Responses to Comments on the Draft EA

On November 18, 2019, the FAA released the Draft Environmental Assessment (EA) for the proposed Las Vegas Metroplex Project for public review and comment. The comment period ran for 64 days and closed on January 21, 2020. The FAA recognizes the importance and value of public input in this process.

Figure 1: GIDGT/RATPK Extended to Blue Diamond Road

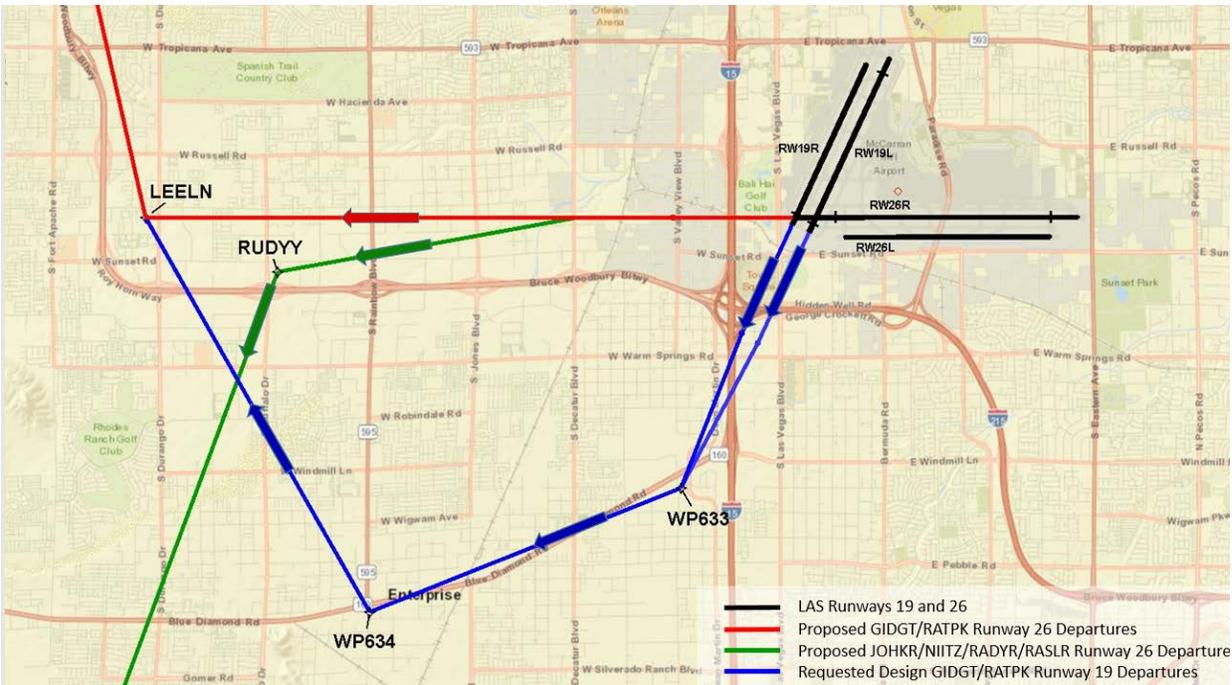
The FAA evaluated a design that delayed making a right turn to LEELN until crossing Blue Diamond Road (approximately 2.5 miles southwest of LAS) (See Figure 1).

The FAA determined that in addition to the criteria failures, the suggested route over Blue Diamond Road would reduce efficiency due to increased delays for departures from separate runways and increase miles flown. Also, extension of the RATPK and GIDGT departure procedures could present a situation where LAS Runway 19 departures would be routed nearly head on toward aircraft on LAS JOHKR, NIITZ, RASLR and RAYDR departure procedures departing LAS Runway 26 (See Figure 1).

Figure 1: GIDGT/RATPK Extended to Blue Diamond Road

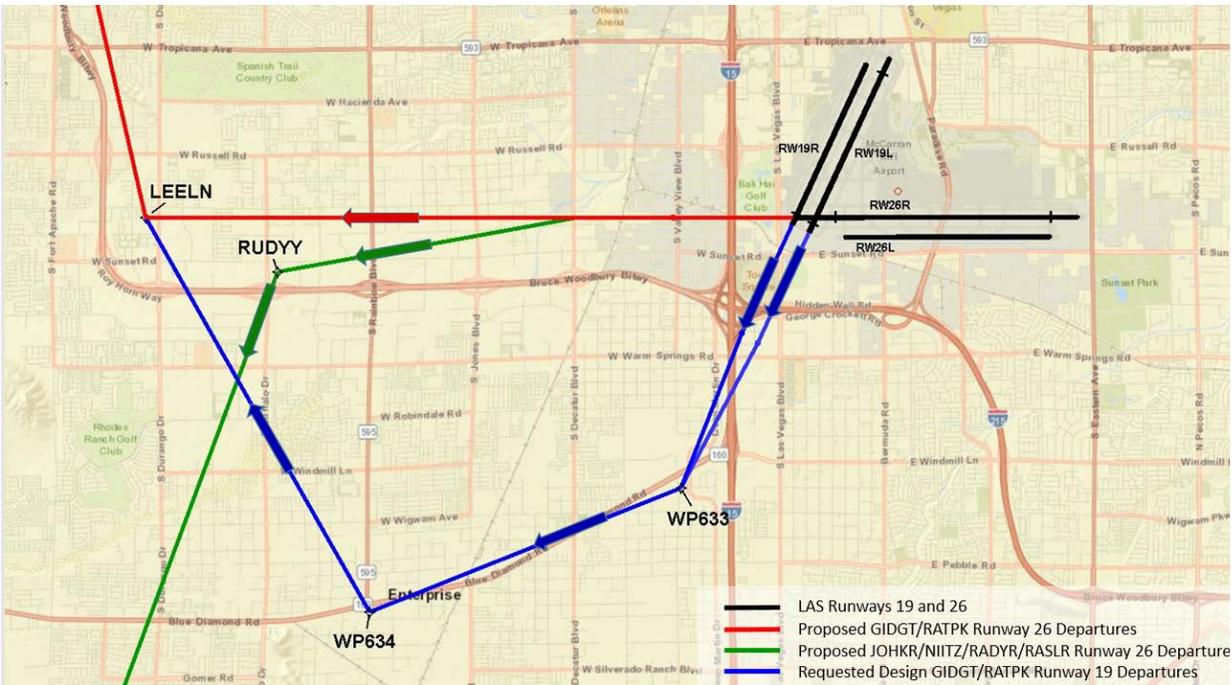
The FAA evaluated a design that delayed making a right turn to LEELN until crossing Blue Diamond Road (approximately 2.5 miles southwest of LAS) (See Figure 1).

The FAA determined that in addition to the criteria failures, the suggested route over Blue Diamond Road would reduce efficiency due to increased delays for departures from separate runways and increase miles flown. Also, extension of the RATPK and GIDGT departure procedures could present a situation where LAS Runway 19 departures would be routed nearly head on toward aircraft on LAS JOHKR, NIITZ, RASLR and RAYDR departure procedures departing LAS Runway 26 (See Figure 1).

Figure 1: GIDGT/RATPK Extended to Blue Diamond Road

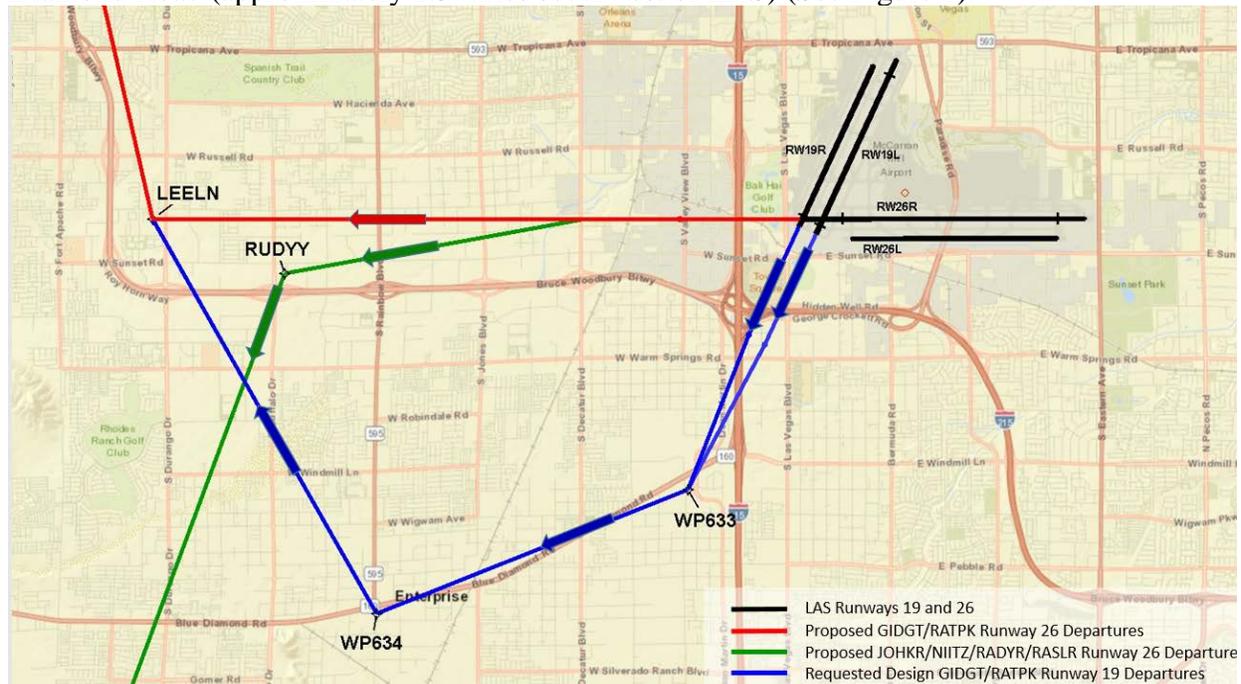
The FAA evaluated a design that delayed making a right turn to LEELN until crossing Blue Diamond Road (approximately 2.5 miles southwest of LAS) (See Figure 1).

The FAA determined that in addition to the criteria failures, the suggested route over Blue Diamond Road would reduce efficiency due to increased delays for departures from separate runways and increase miles flown. Also, extension of the RATPK and GIDGT departure procedures could present a situation where LAS Runway 19 departures would be routed nearly head on toward aircraft on LAS JOHKR, NIITZ, RASLR and RAYDR departure procedures departing LAS Runway 26 (See Figure 1).

Figure 1: GIDGT/RATPK Extended to Blue Diamond Road

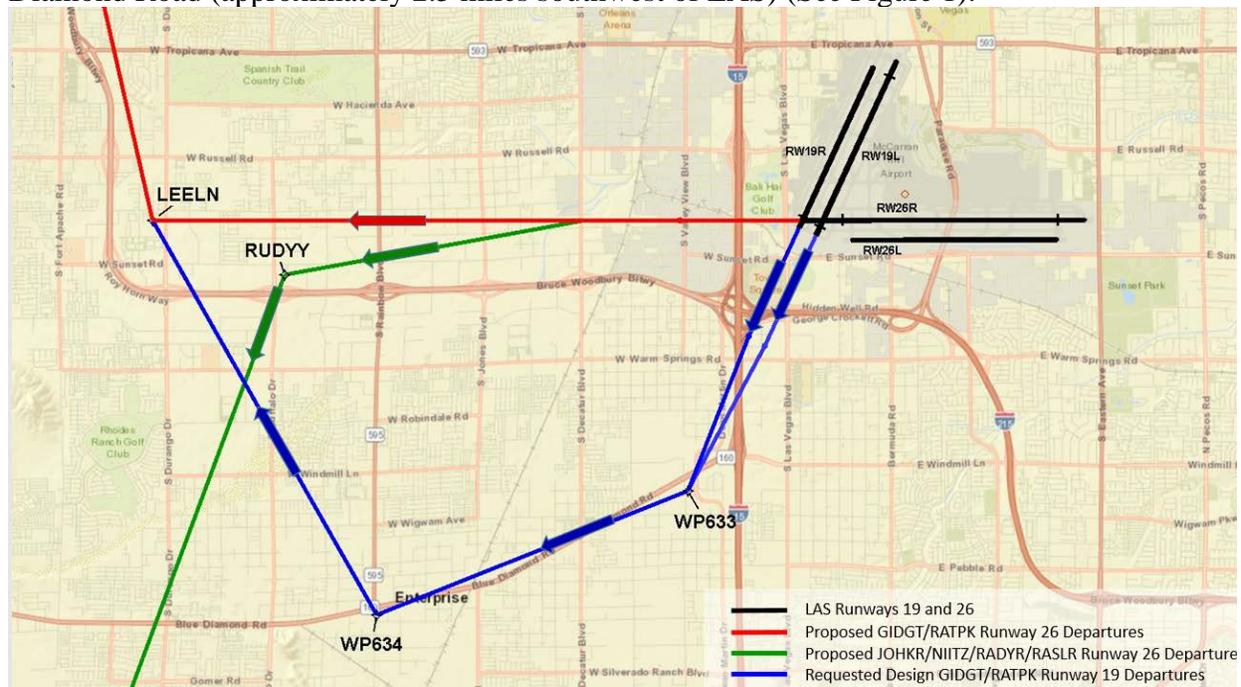
The FAA evaluated a design that delayed making a right turn to LEELN until crossing Blue Diamond Road (approximately 2.5 miles southwest of LAS) (See Figure 1).

The FAA determined that in addition to the criteria failures, the suggested route over Blue Diamond Road would reduce efficiency due to increased delays for departures from separate runways and increase miles flown. Also, extension of the RATPK and GIDGT departure procedures could present a situation where LAS Runway 19 departures would be routed nearly head on toward aircraft on LAS JOHKR, NIITZ, RASLR and RAYDR departure procedures departing LAS Runway 26 (See Figure 1).

Figure 1: GIDGT/RATPK Extended to Blue Diamond Road

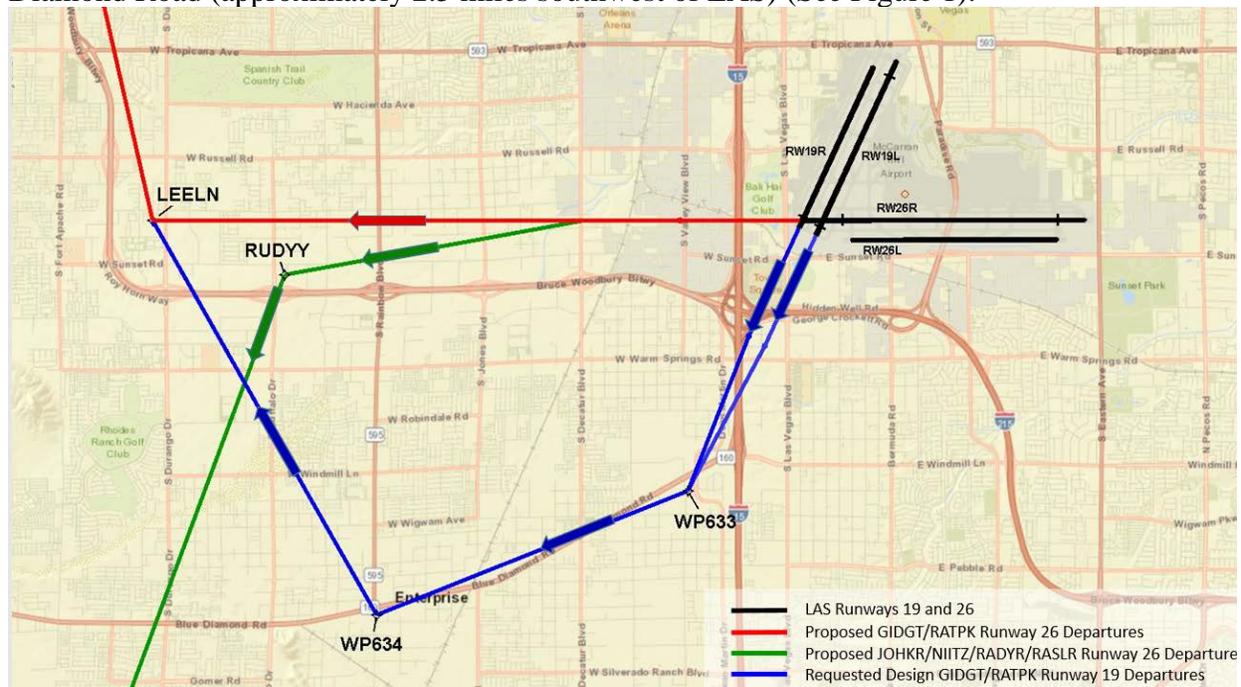
The FAA evaluated a design that delayed making a right turn to LEELN until crossing Blue Diamond Road (approximately 2.5 miles southwest of LAS) (See Figure 1).

The FAA determined that in addition to the criteria failures, the suggested route over Blue Diamond Road would reduce efficiency due to increased delays for departures from separate runways and increase miles flown. Also, extension of the RATPK and GIDGT departure procedures could present a situation where LAS Runway 19 departures would be routed nearly head on toward aircraft on LAS JOHKR, NIITZ, RASLR and RAYDR departure procedures departing LAS Runway 26 (See Figure 1).

Figure 1: GIDGT/RATPK Extended to Blue Diamond Road

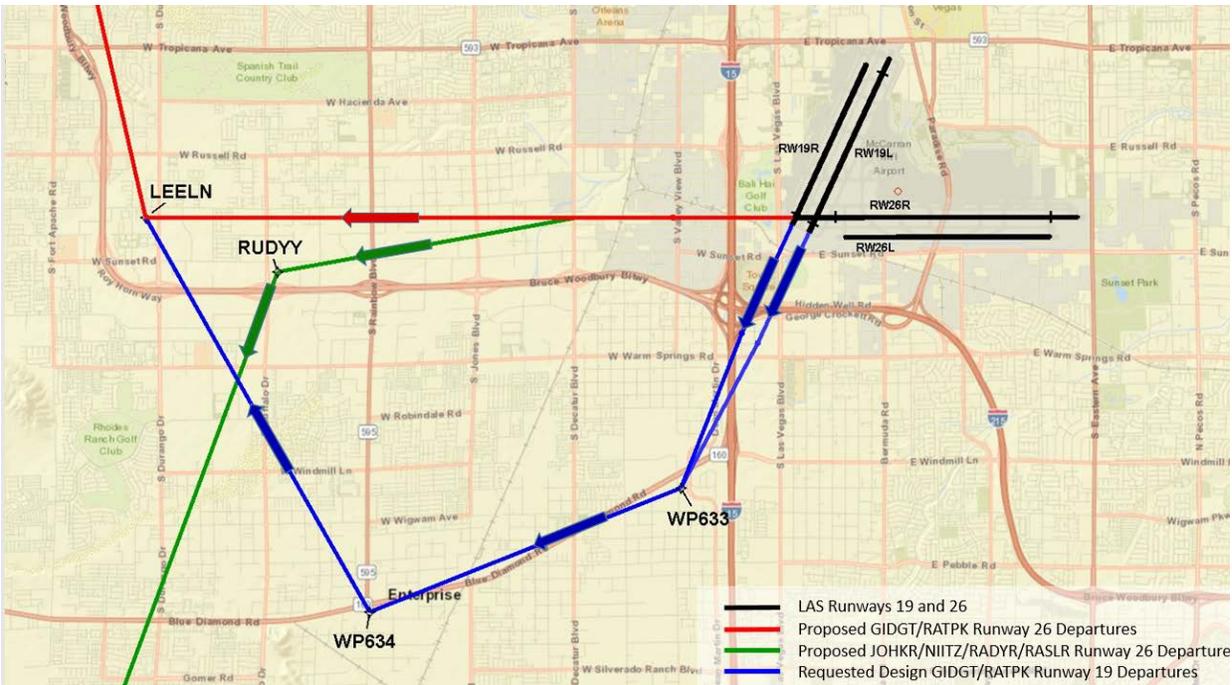
The FAA evaluated a design that delayed making a right turn to LEELN until crossing Blue Diamond Road (approximately 2.5 miles southwest of LAS) (See Figure 1).

The FAA determined that in addition to the criteria failures, the suggested route over Blue Diamond Road would reduce efficiency due to increased delays for departures from separate runways and increase miles flown. Also, extension of the RATPK and GIDGT departure procedures could present a situation where LAS Runway 19 departures would be routed nearly head on toward aircraft on LAS JOHKR, NIITZ, RASLR and RAYDR departure procedures departing LAS Runway 26 (See Figure 1).

Figure 1: GIDGT/RATPK Extended to Blue Diamond Road

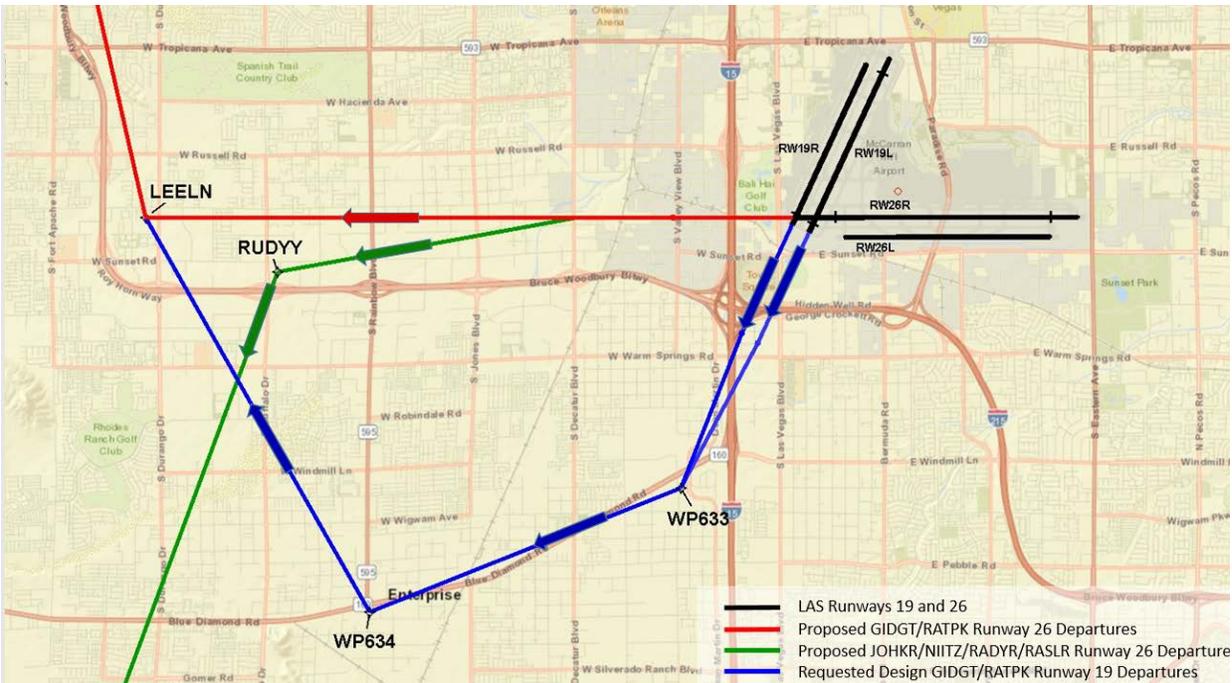
The FAA evaluated a design that delayed making a right turn to LEELN until crossing Blue Diamond Road (approximately 2.5 miles southwest of LAS) (See Figure 1).

The FAA determined that in addition to the criteria failures, the suggested route over Blue Diamond Road would reduce efficiency due to increased delays for departures from separate runways and increase miles flown. Also, extension of the RATPK and GIDGT departure procedures could present a situation where LAS Runway 19 departures would be routed nearly head on toward aircraft on LAS JOHKR, NIITZ, RASLR and RAYDR departure procedures departing LAS Runway 26 (See Figure 1).

Figure 1: GIDGT/RATPK Extended to Blue Diamond Road

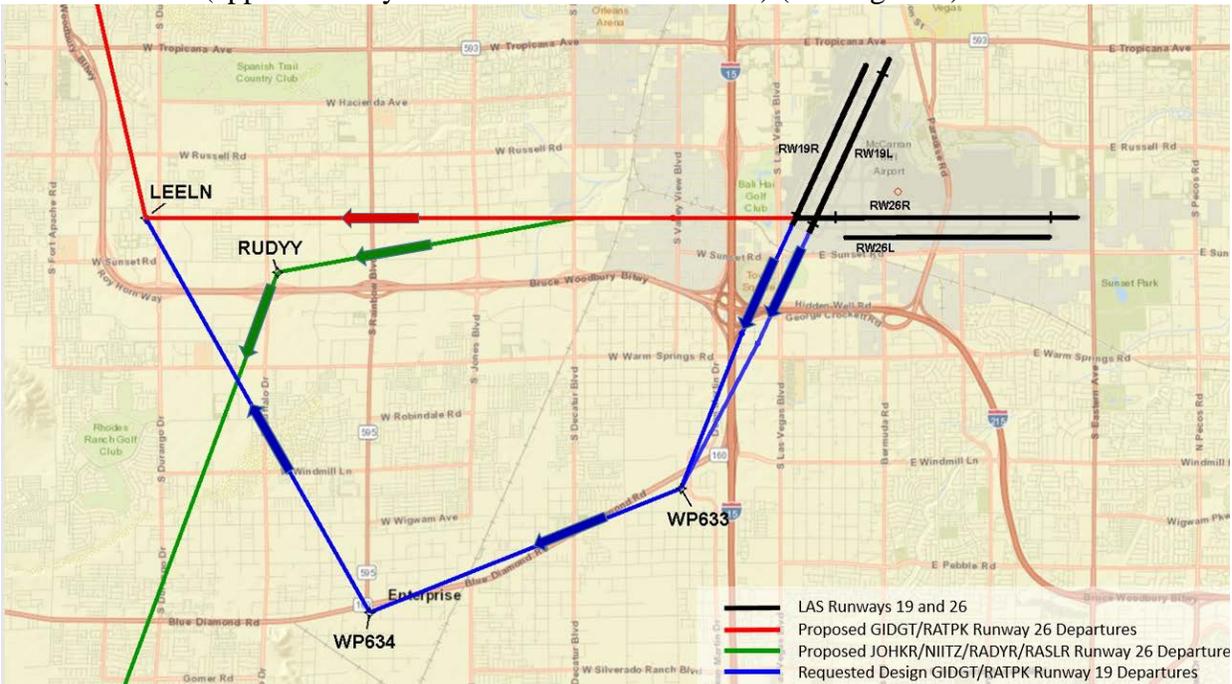
The FAA evaluated a design that delayed making a right turn to LEELN until crossing Blue Diamond Road (approximately 2.5 miles southwest of LAS) (See Figure 1).

The FAA determined that in addition to the criteria failures, the suggested route over Blue Diamond Road would reduce efficiency due to increased delays for departures from separate runways and increase miles flown. Also, extension of the RATPK and GIDGT departure procedures could present a situation where LAS Runway 19 departures would be routed nearly head on toward aircraft on LAS JOHKR, NIITZ, RASLR and RAYDR departure procedures departing LAS Runway 26 (See Figure 1).

Figure 1: GIDGT/RATPK Extended to Blue Diamond Road

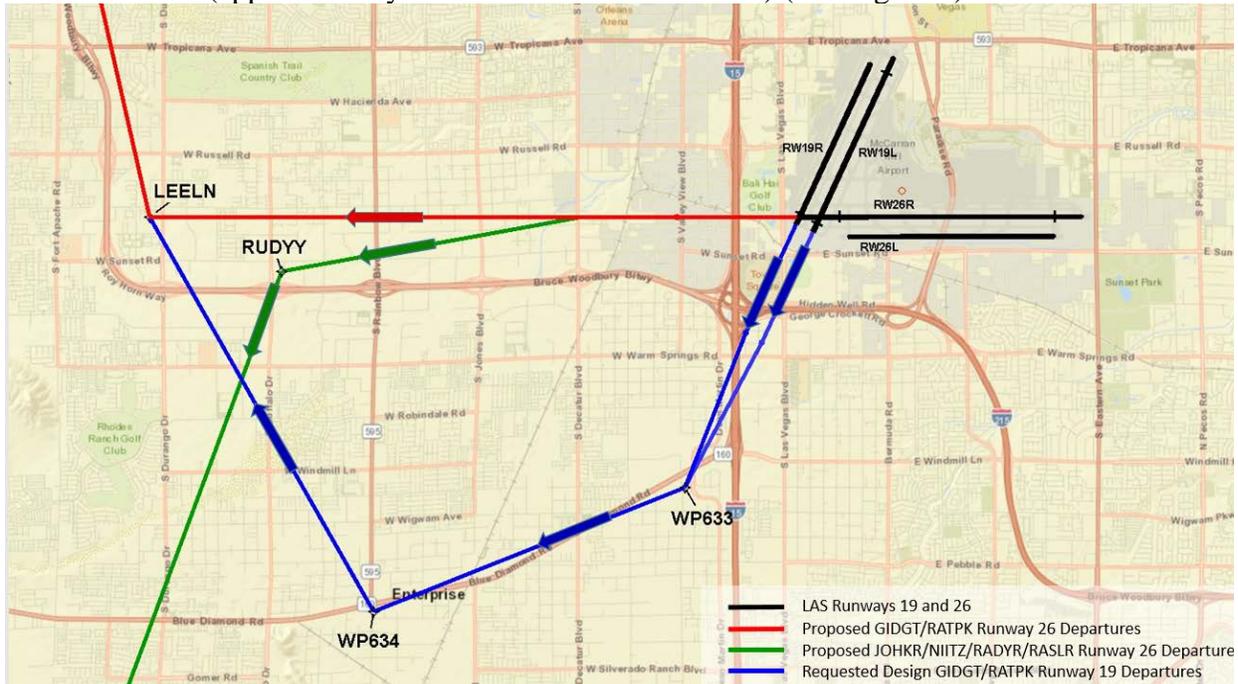
The FAA evaluated a design that delayed making a right turn to LEELN until crossing Blue Diamond Road (approximately 2.5 miles southwest of LAS) (See Figure 1).

The FAA determined that in addition to the criteria failures, the suggested route over Blue Diamond Road would reduce efficiency due to increased delays for departures from separate runways and increase miles flown. Also, extension of the RATPK and GIDGT departure procedures could present a situation where LAS Runway 19 departures would be routed nearly head on toward aircraft on LAS JOHKR, NIITZ, RASLR and RAYDR departure procedures departing LAS Runway 26 (See Figure 1).

Figure 1: GIDGT/RATPK Extended to Blue Diamond Road

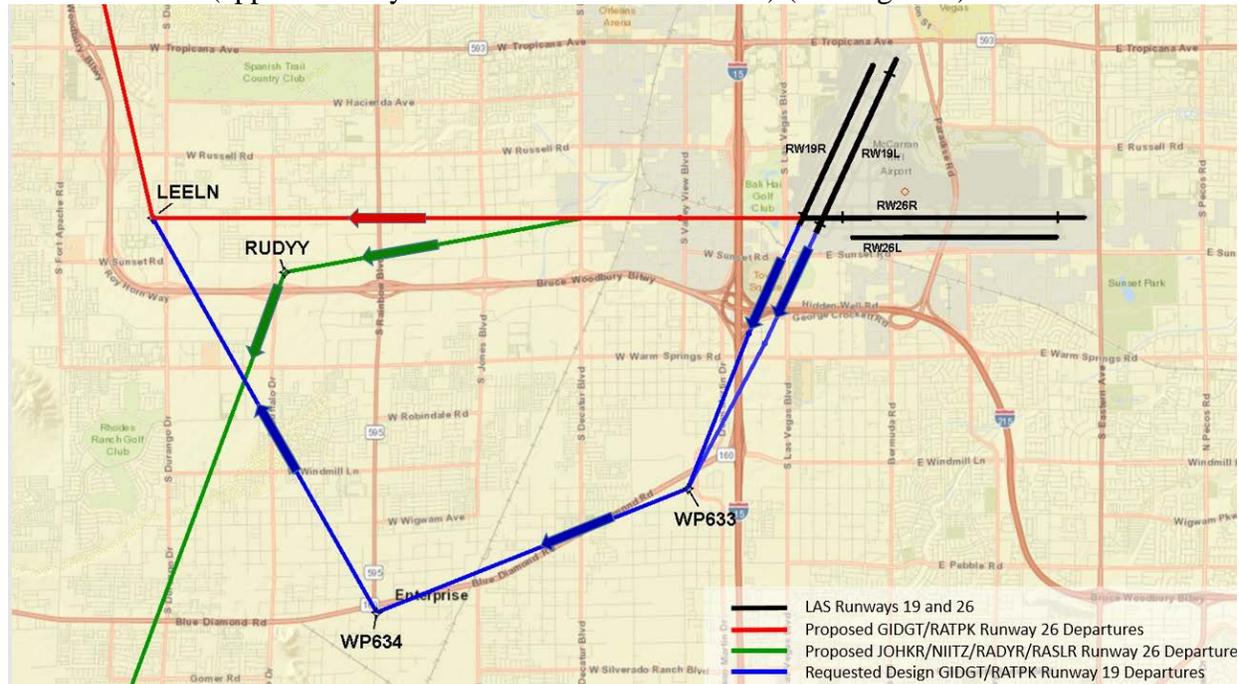
The FAA evaluated a design that delayed making a right turn to LEELN until crossing Blue Diamond Road (approximately 2.5 miles southwest of LAS) (See Figure 1).

The FAA determined that in addition to the criteria failures, the suggested route over Blue Diamond Road would reduce efficiency due to increased delays for departures from separate runways and increase miles flown. Also, extension of the RATPK and GIDGT departure procedures could present a situation where LAS Runway 19 departures would be routed nearly head on toward aircraft on LAS JOHKR, NIITZ, RASLR and RAYDR departure procedures departing LAS Runway 26 (See Figure 1).

Figure 1. Flight Tracks over or near 1L3 at or below 15,000 feet above mean sea level

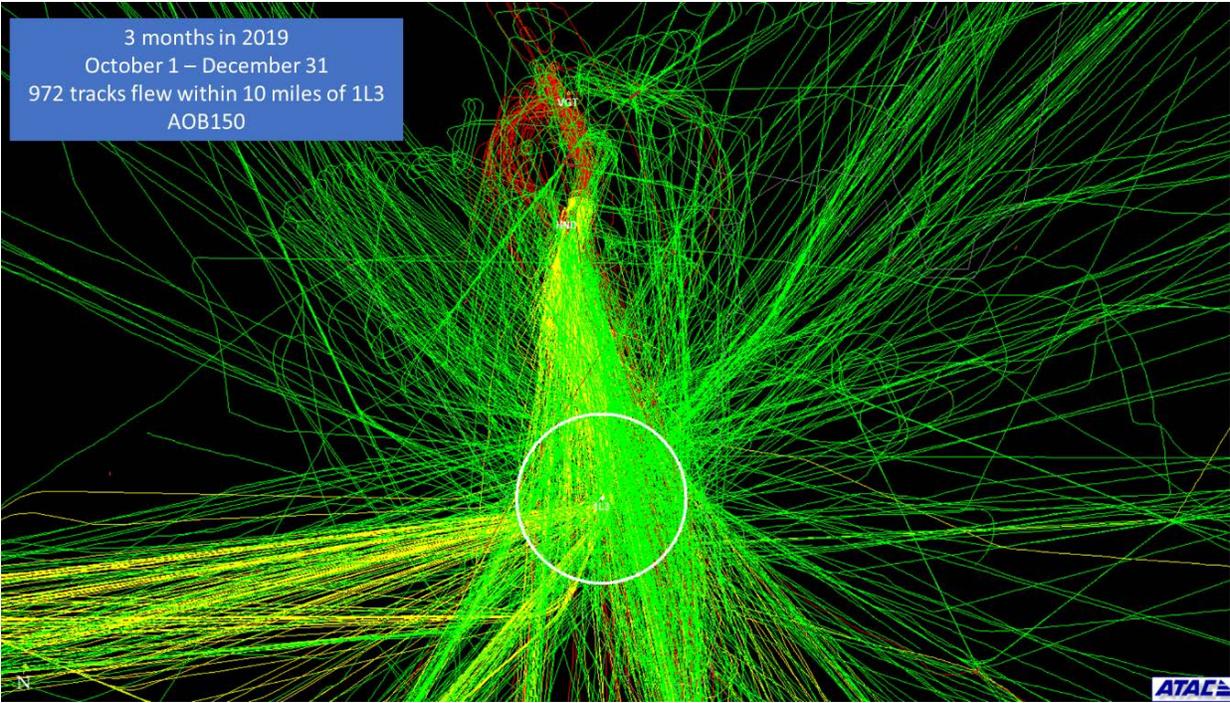
The Federal Aviation Administration (FAA) reviewed historical flight data for the period of October 1, 2019 to December 31, 2019. Using a ten nautical mile diameter circle centered on 1L3, there were a total of 972 flights that entered the defined area at or below 15,000 feet mean sea level, or 11,450 feet above ground level. See **Figure 1**. Of these, 382 landed at either HND or VGT. See **Figure 2**. This number represents only aircraft receiving air traffic control services. There is no way to determine the number of aircraft overflying 1L3 that were not receiving air traffic services.

After review, the FAA determined that the proposed NTNDO arrival procedure could not be moved or eliminated due to safety and efficiency considerations.
